Virtual Site Plan Review Committee #2

Marbella Apartments

New Site Plan #463

1300 and 1305 North Pierce Street (RPC #17-033-006, -009, -016, -017)

Density and Building Transition

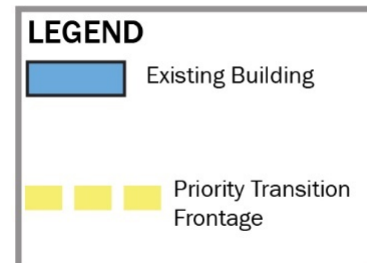
- Building transition to lower density sites
 - Primarily on the north property frontage of the west Phase 1 building
 - Additional building setback and/or step-back should be considered
 - Any conflicts to landscaping implementation should be identified
- Design treatment at the ground level
 - Parking and loading entrance treatments
 - Transformer screening along west Phase 1 building pedestrian path

- “RA6-15” By-Right – **103 units**
- “RA6-15” Site Plan (*Per Section 12.3.7) – **127 units**
- “RA6-15” Site Plan (*Per Section 15.5.9) – **no density limitation**
 - 555 units currently proposed
 - 337% increase over maximum market rate development
 - *“Such modifications may be approved when the County Board finds that...**The applicant’s site layout and proposed building heights have been designed in a manner to establish effective transitions to lower density residential neighborhoods** using site topography, landscaping, architectural façade treatments, graduated building heights, increased setbacks, or other similar measures.”*
